Docket No. 50-271

Change No. 12
License No. DPR-28

SAFETY EVALUATION BY THE DIRECTORATE OF LICENSING

CHANGE NO. 12 TO THE TECHNICAL SPECIFICATIONS

Figure 3.5.1 Maximum Allowable Planar LHGR

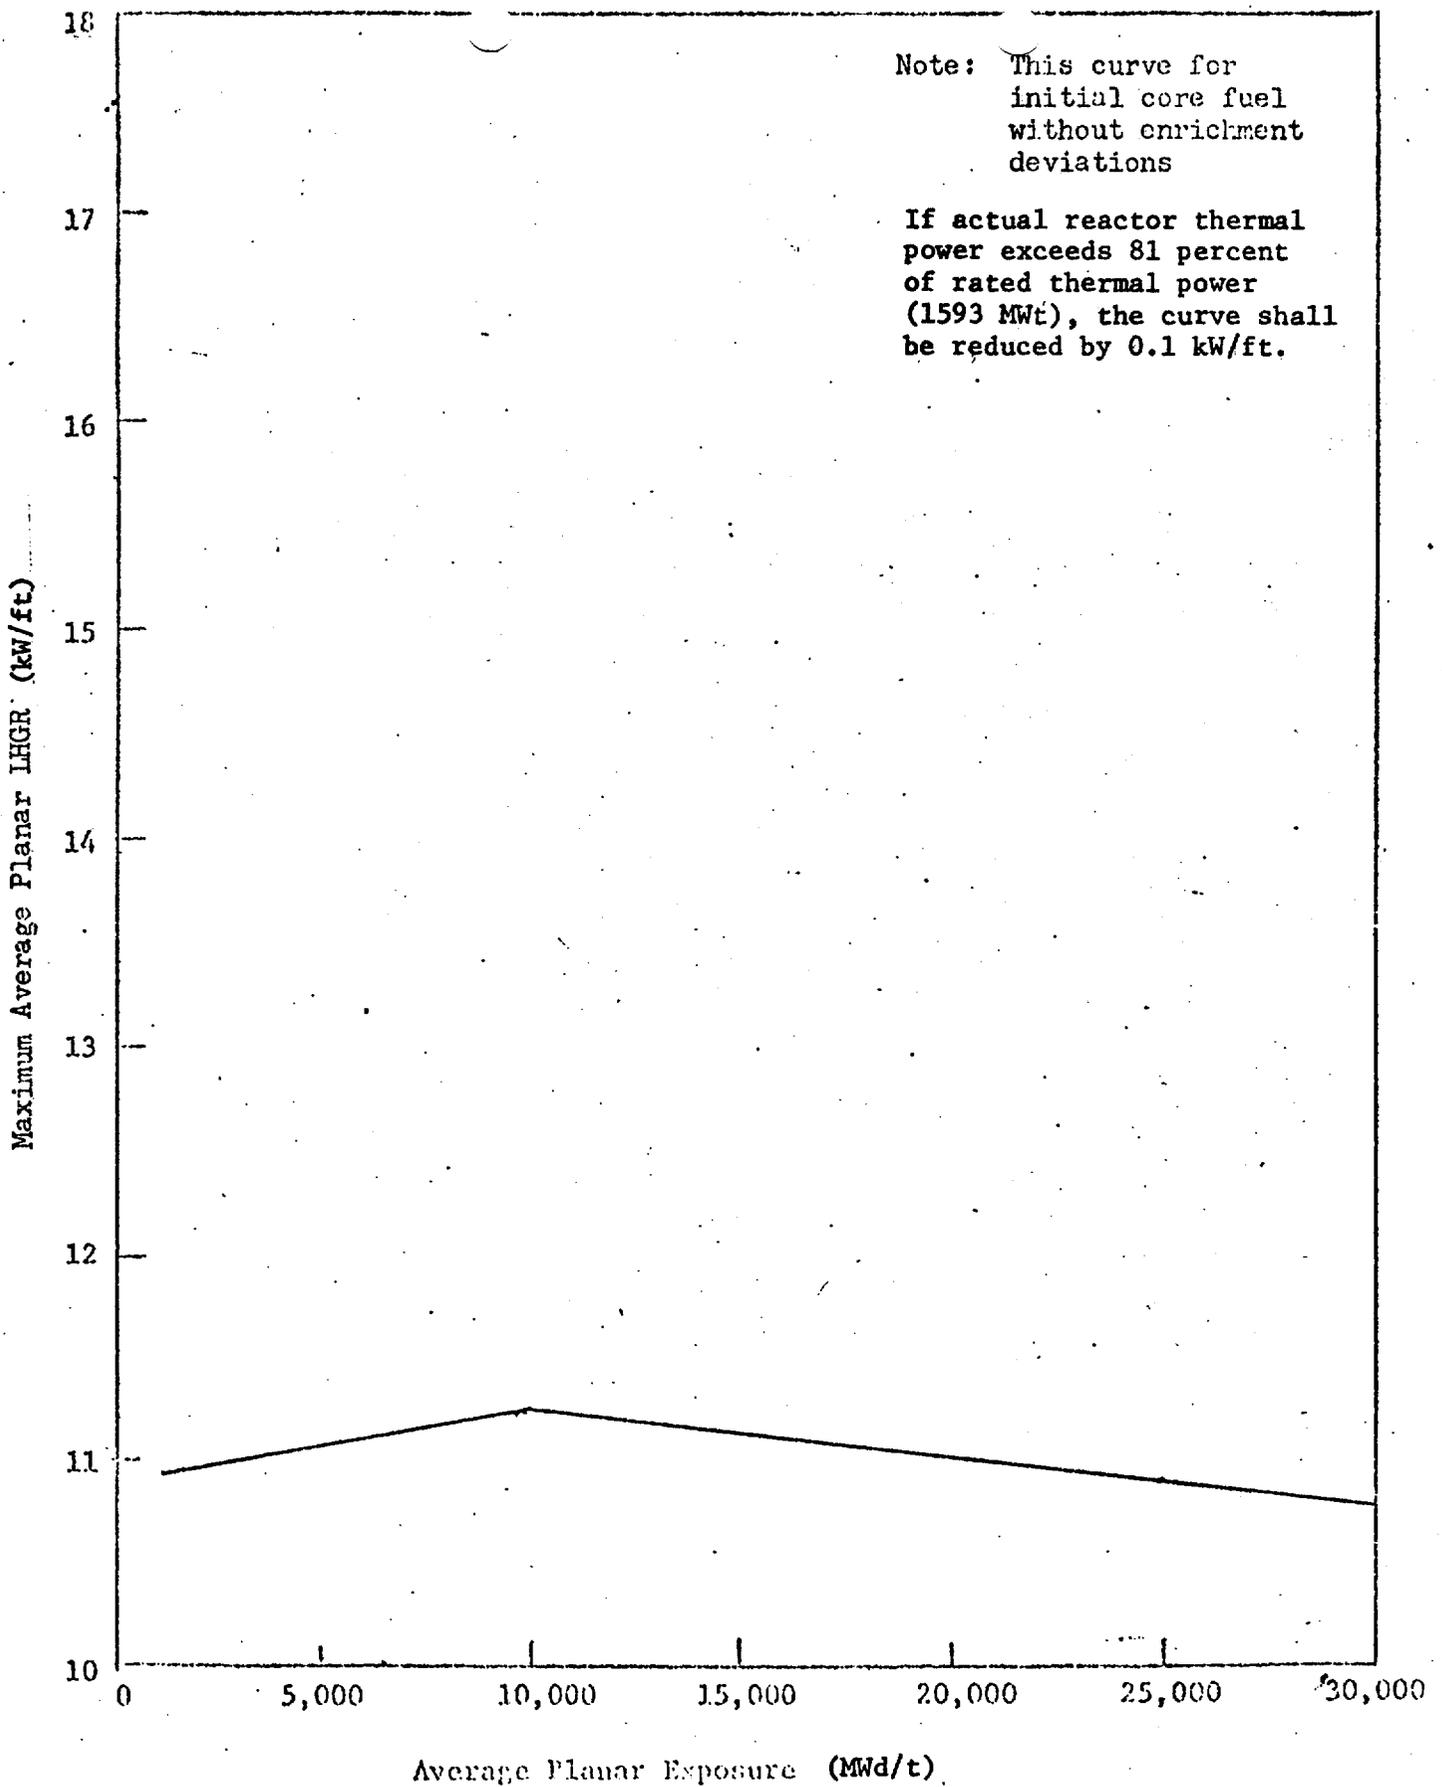
Accordingly, pursuant to Section 50.59 of 10 CFR Part 50, the Technical Specifications appended to Facility License No. DPR-28 are hereby changed by replacing Figures 3.5.1 and 3.5.1A with the enclosed revised figures dated November 6, 1973, and by adding the enclosed Figure 3.5.1B.

We have evaluated the proposed changes to the maximum average planar linear heat generation rate (MAPLHGR) curves in the Technical Specifications. We have concluded that these MAPLHGR curves were determined using the Interim Acceptance Criteria calculational model, including the effects of fuel densification, and use of these MAPLHGR curves will not result in a peak clad temperature in excess of 2300°F during the loss-of-coolant design basis accident. Therefore, the Interim Acceptance Criteria will be satisfied during operation of the reactor in the proposed manner. The MAPLHGR curves are based on computer calculations out to 30,000 MWd/t exposure as requested by our October 26, 1973 letter for the initial core fuel with and without enrichment deviations. The MAPLHGR curve for the reload fuel is based on computer calculations out to 10,000 MWd/t exposure since the reload fuel will not be depleted to average exposure greater than this during the next operating cycle. Since the reanalysis to determine the MAPLHGR curves was based on a rated thermal power level of 81 percent or less, the proposed figures have been modified by adding a note to the figures in the Technical Specifications stating that the MAPLHGR curves must be reduced by 0.1 kW/ft if the stated power level is exceeded.

OFFICE	or less, the proposed figures have been modified by adding a
SURNAME	note to the figures in the Technical Specifications stating that the
DATE	MAPLHGR curves must be reduced by 0.1 kW/ft ² if the stated power level
	is exceeded. is

Figure 3.5.1.B Maximum Allowable Planar LHGR

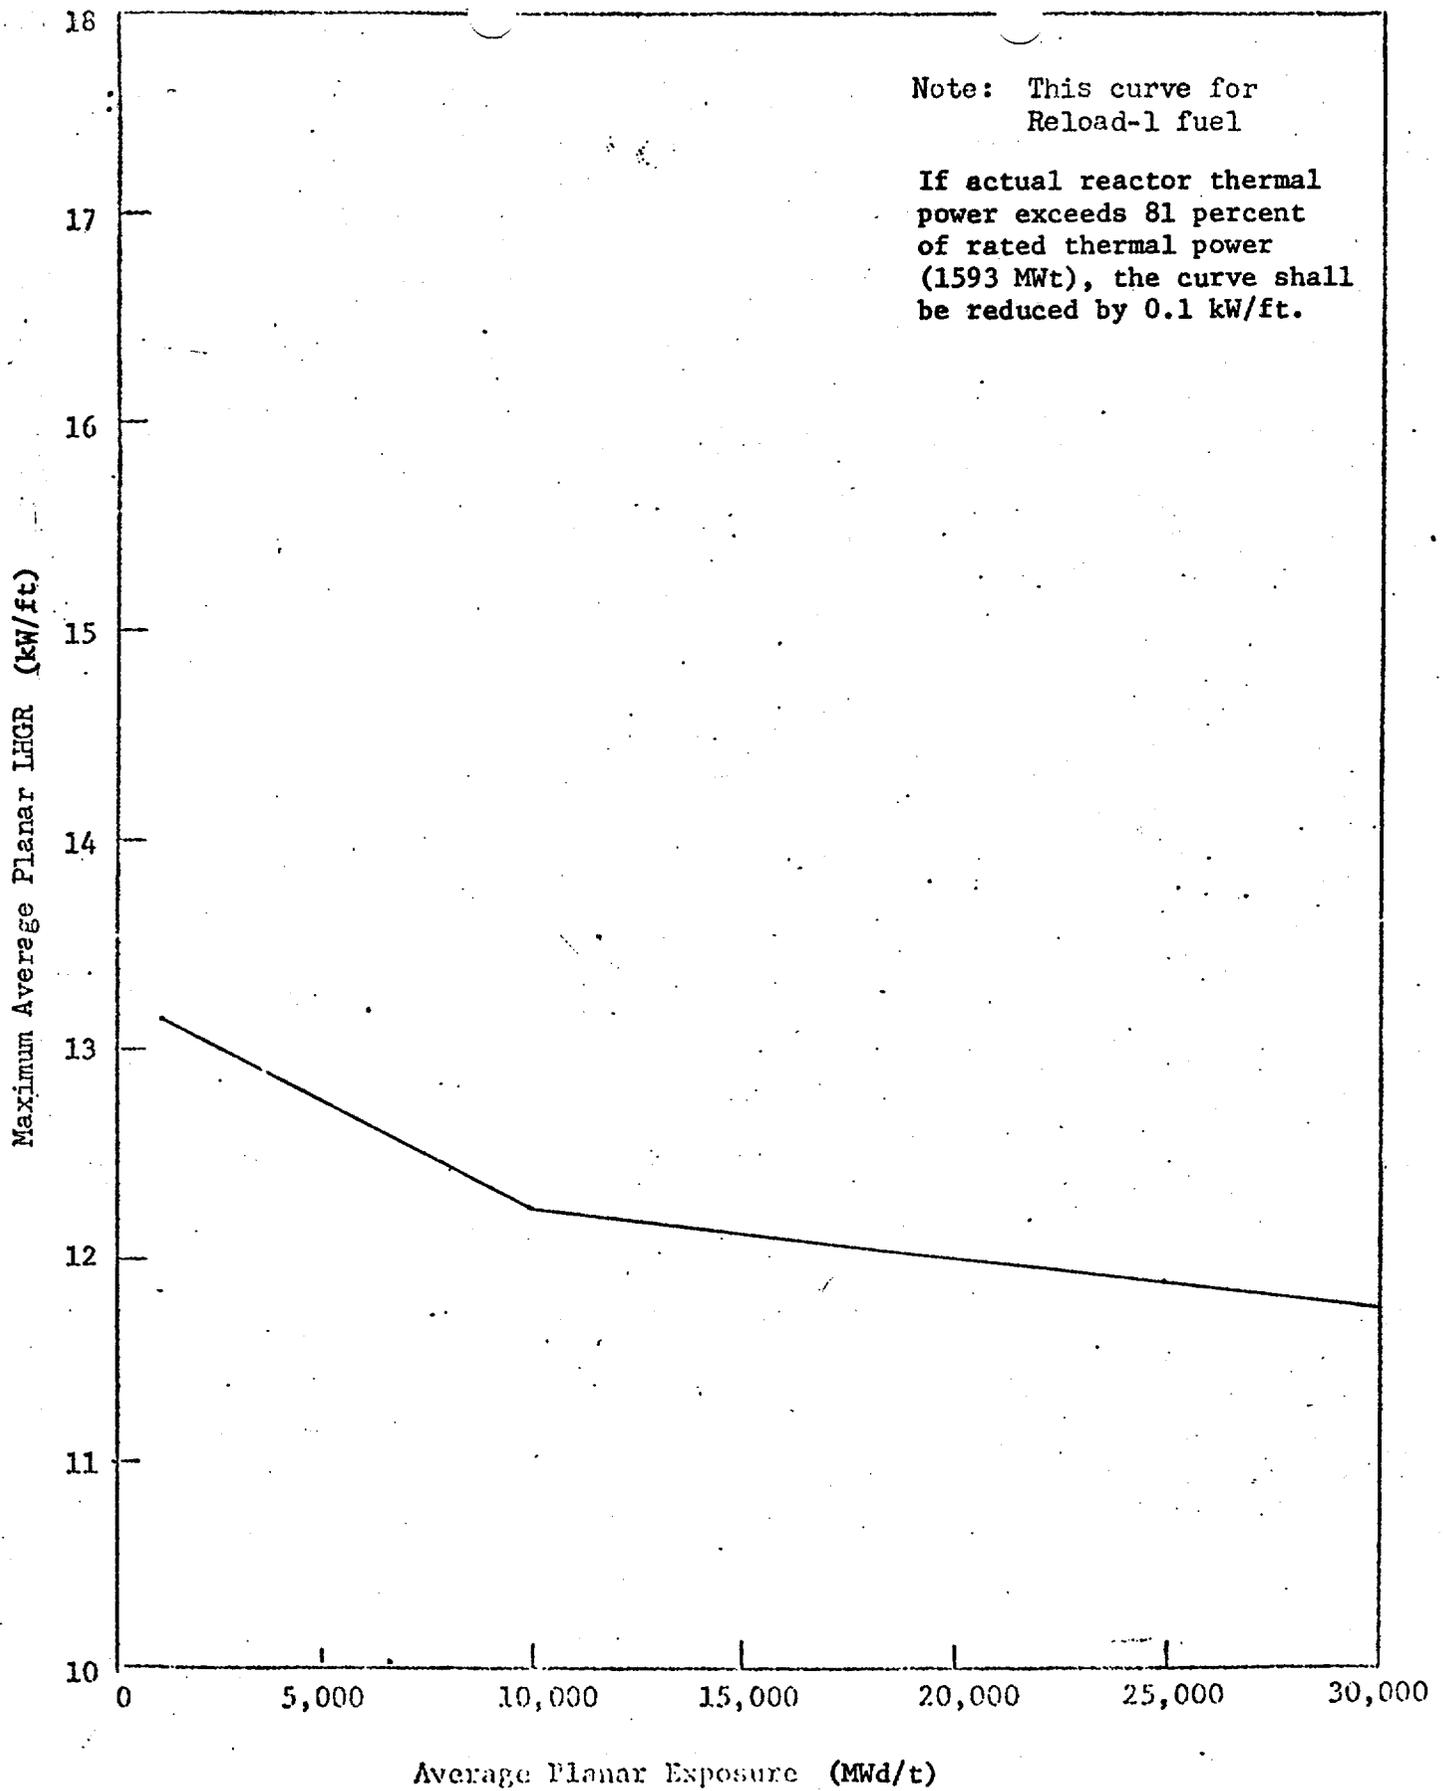
The MAPLHGR curves for the initial core fuel with and without enrichment deviations are based on computer calculations out to 30,000 MWd/t exposure as requested by our October 26, 1973 letter. The MAPLHGR curve for the reload-1 fuel assemblies are based on computer calculations with an assumed fuel planar average exposure of 10,000 MWd/t but have been extrapolated for higher exposures. Since the reload fuel assemblies will not be depleted to an average exposure greater than 10,000 MWd/t during the next operating cycle, the proposed curve is acceptable for this operating cycle. A revised MAPLHGR graph for the reload fuel assemblies, based on detailed heat up calculations at higher burnups, will be required for operation beyond this operating cycle.

The MAPLHGR curves are based on computer calculations out to 30,000 MWd/t exposure as requested by our October 26, 1973 letter for the initial core fuel with and without enrichment deviations. The MAPLHGR curve for the reload fuel ~~is~~ based on computer calculations out to 10,000 MWd/t exposure since the reload fuel will not be depleted to average exposure greater than this during the next operating cycle. Since the reanalysis to determine the MAPLHGR curves ~~was~~ based on a rated thermal power level of 81 percent
